AGENDA
CHASKA PLANNING COMMISSION
ONE CITY HALL PLAZA, CHASKA CITY HALL
Wednesday, March 13, 2019
7:00 PM

**REQUEST FOR ACTION
CHASKA PLANNING COMMISSION
03/13/2019**

Subject: Hazel View Senior Cooperative – Concept Plan

Subject: Former KFC Building (798 Yellow Brick Road) – Preliminary Site Plan

contents
EXTERIOR ELEVATIONS
job no.
18-09

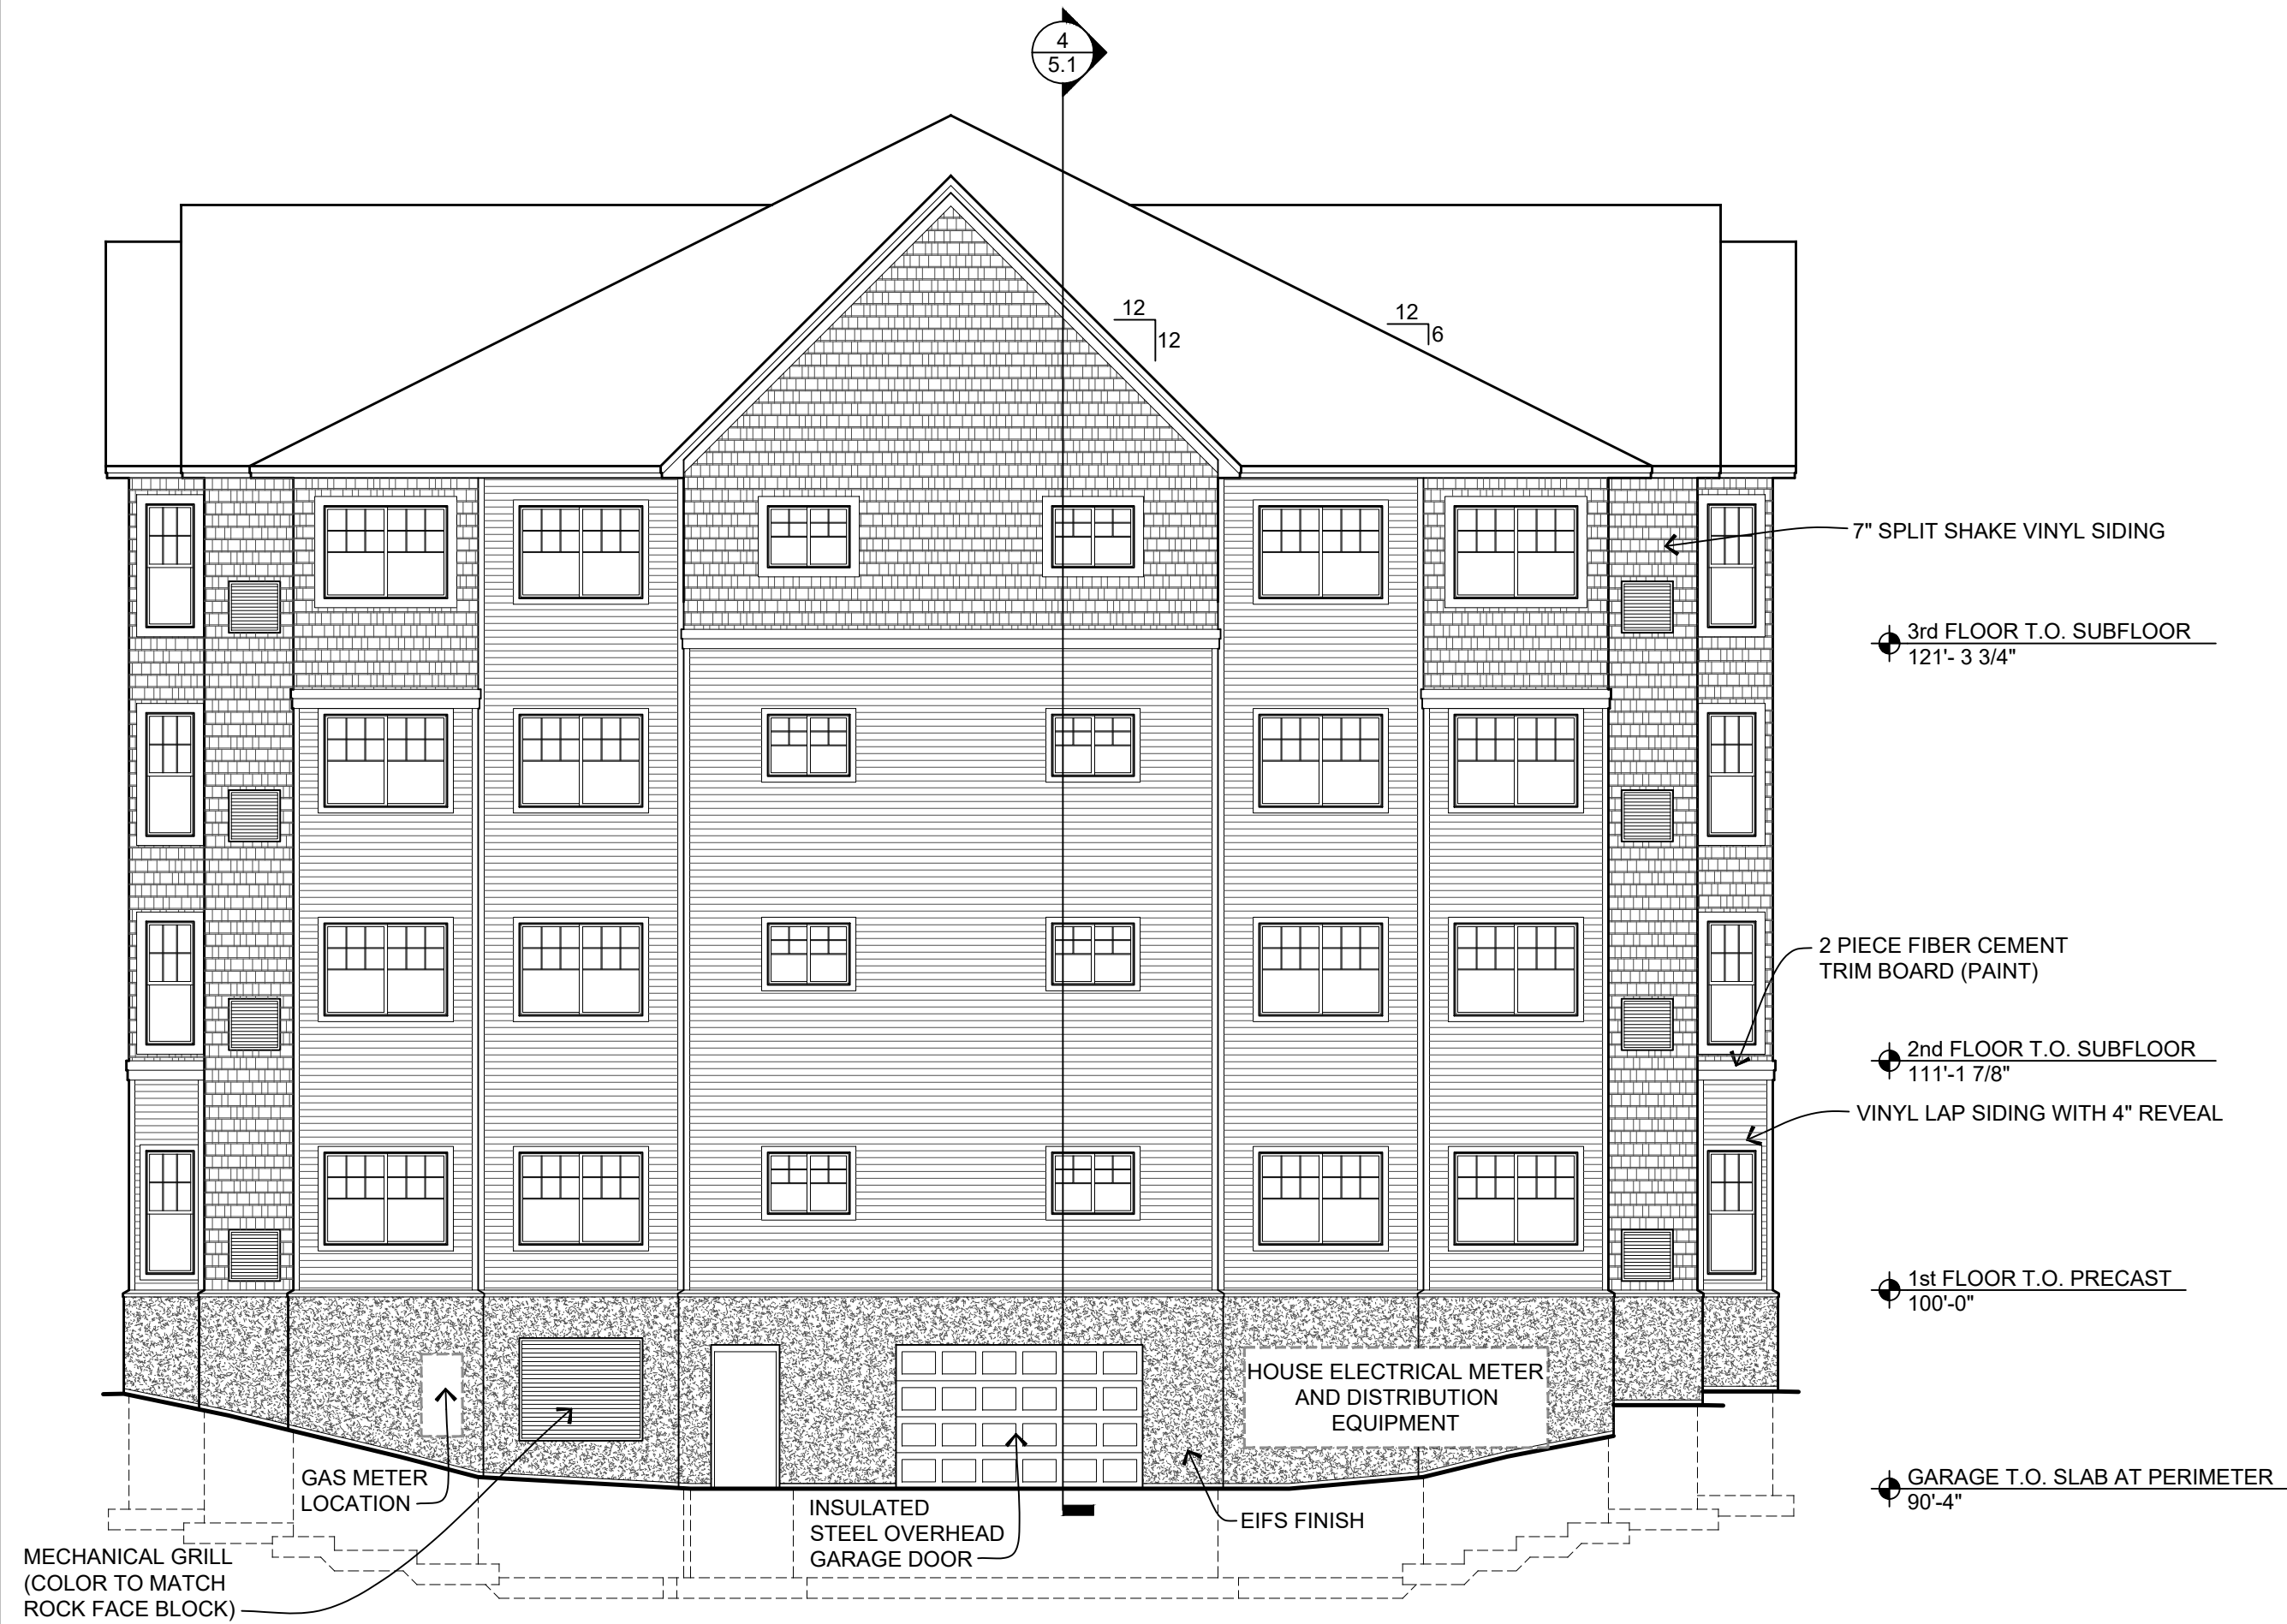
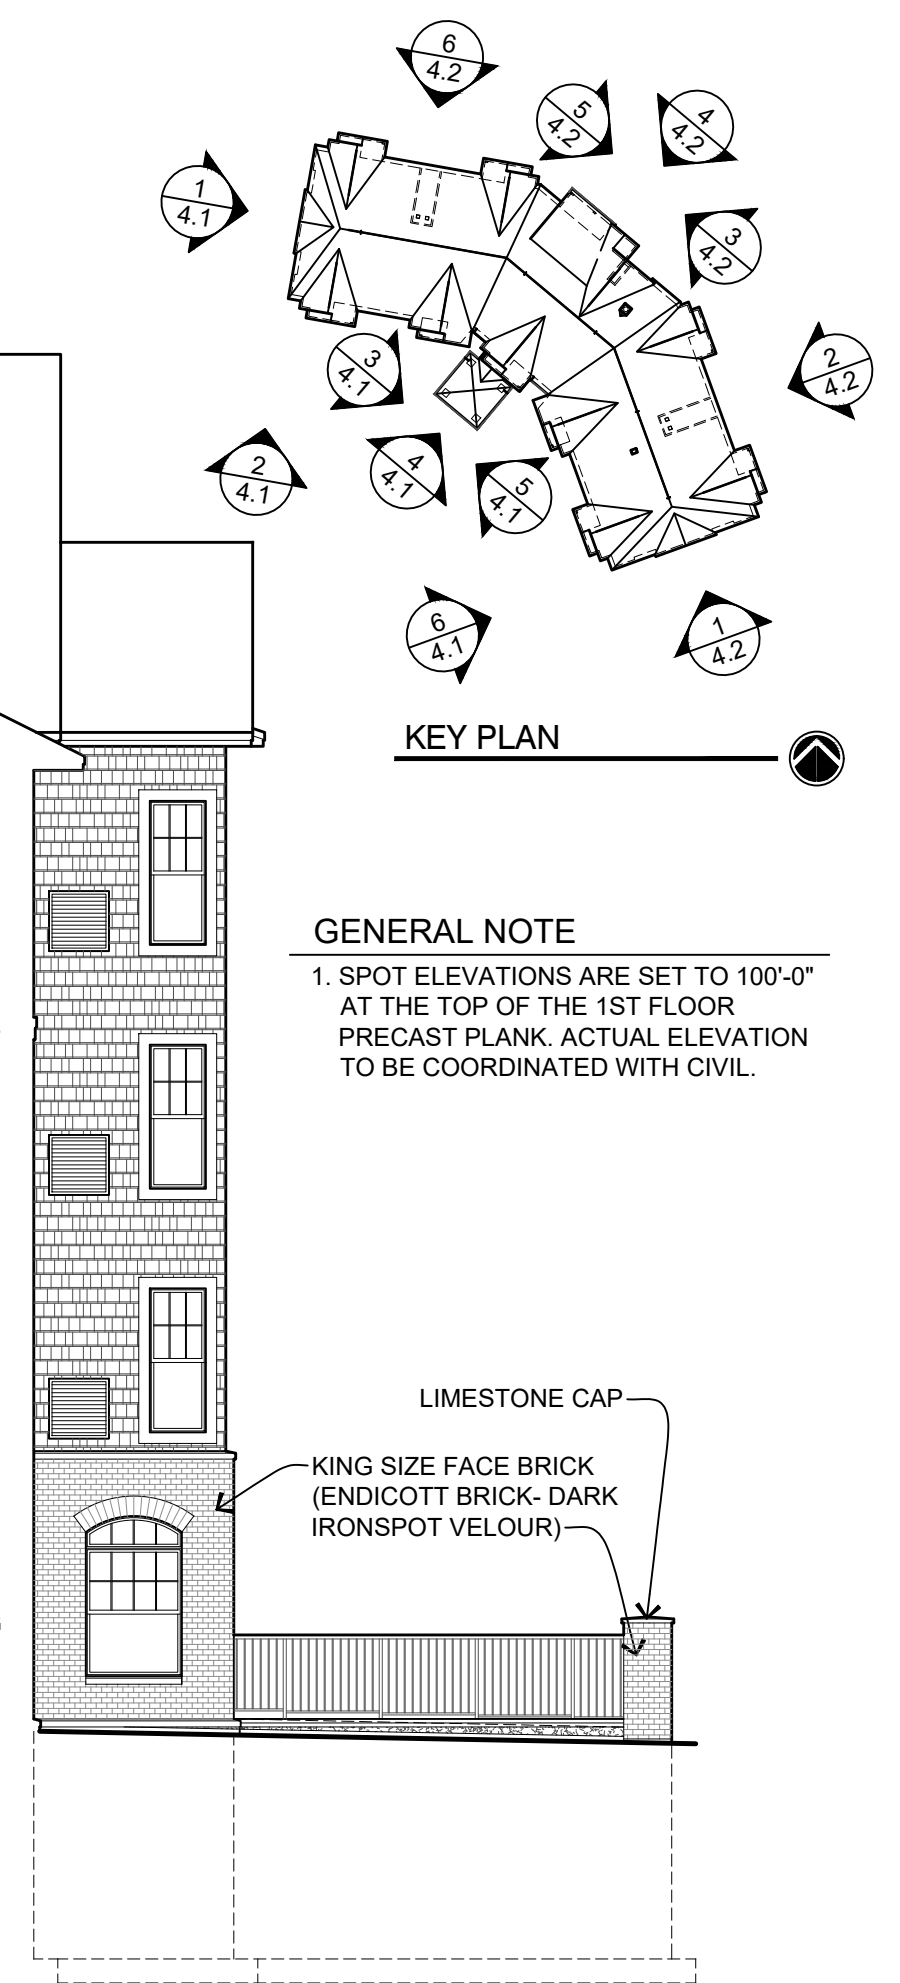
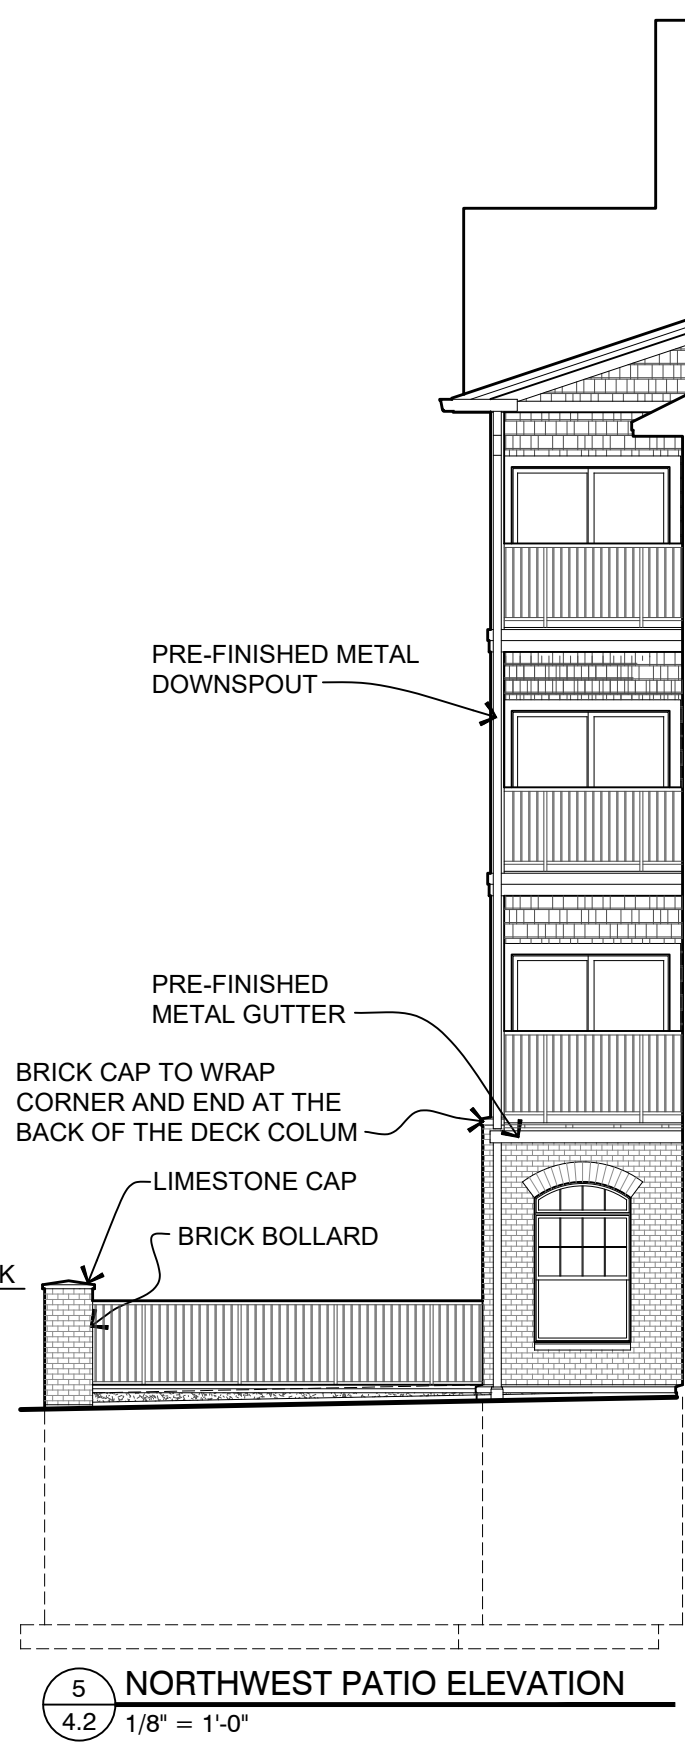
The applicant will have to show in their preliminary submittal how they will meet this requirement. An item of note is the brick to be used. In order to be classified as a Class I material, the brick needs to be a full modular face brick.

The applicant has provided a couple renderings/drawings of the building. The building's exterior appearance appears to show a well-balanced application of materials and depth. Given that this building will have high visibility on all of its sides, staff would advise that 360 degree architecture is achieved throughout the building. In addition to that, the building will have to show how it fits into the context of Chaska.

Another point that staff would like to point out is the roof profile. This building is proposed to be 4-stories tall, which already is taller than the adjacent townhomes. An option to look into is a flat roof, like the one at Lake Jonathan Flats. Not only will this shave off some height on the building but it will also provide opportunities for rooftop amenities. Staff would advise the applicant to look into this more. If this is explored, staff would advise that the building still provide visual interest on the roofline by way of varying roof lines and parapet detailing.

6. Provision that all facades provide 360 degree architecture.
7. Provision to further explore a flat roof profile for the purpose of shorter height and rooftop amenities.

Preliminary Site Plan

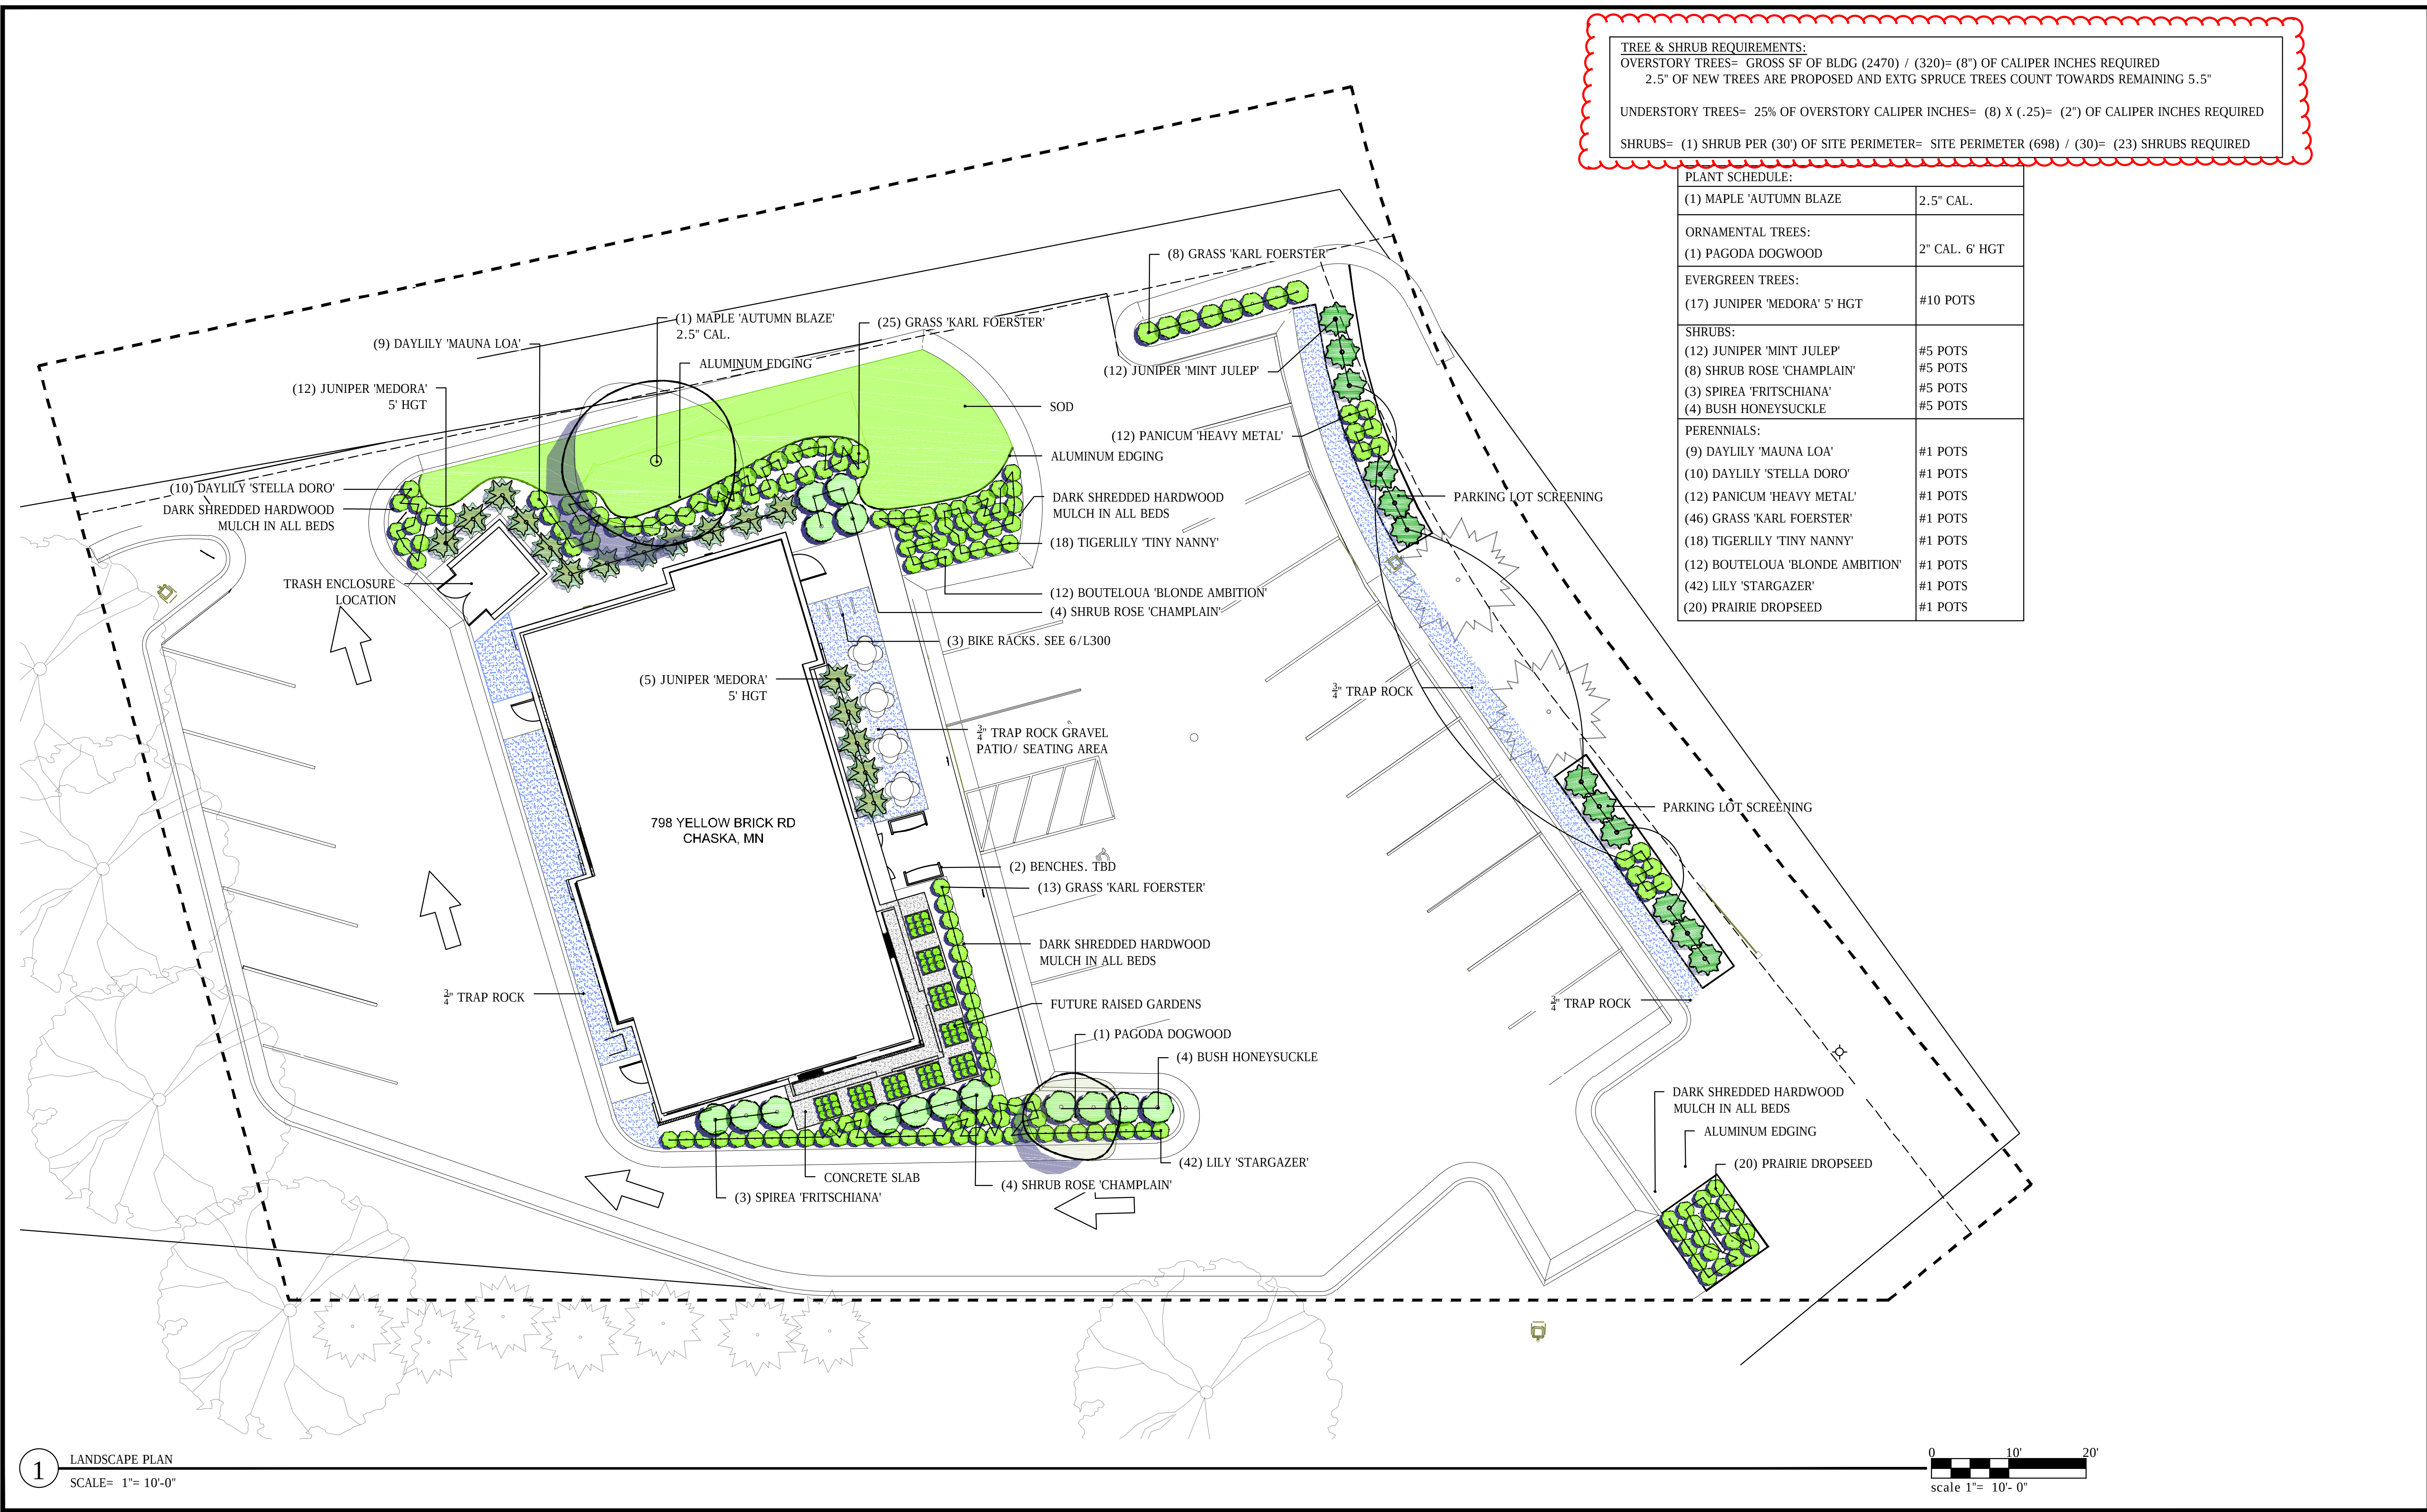
The plan is to continue to use the existing accesses into the site from the private drive. The building is situated in the center of the site with vehicle movement around the building; the parking lot will remain intact however the west portion will become a one-way system. A drive-thru component exists on the west and north façades, however this component will be removed as a part of the remodel.

According to this table the applicant is meeting the required amount of parking spaces needed for the use. Parking spaces will be provided on the west and east sides of the buildings. The proposed parking lot will provide full access into the site on the easterly access on the north side. Customers will mainly park on the east side of the building. The west side is mainly designated for employees. The west side of the parking lot will be a one-way system to allow people to exit the site. People will not be able to enter the site from this side. As stated before, the drive-thru aisle on the north side of the building will be removed and replaced with green space. The parking lot will be resurfaced and re-striped.

- 11. Provision that drive aisles are at least 24 feet in width.**
- 12. Provision of a photometric plan meeting lighting ordinance Section 9.24.**
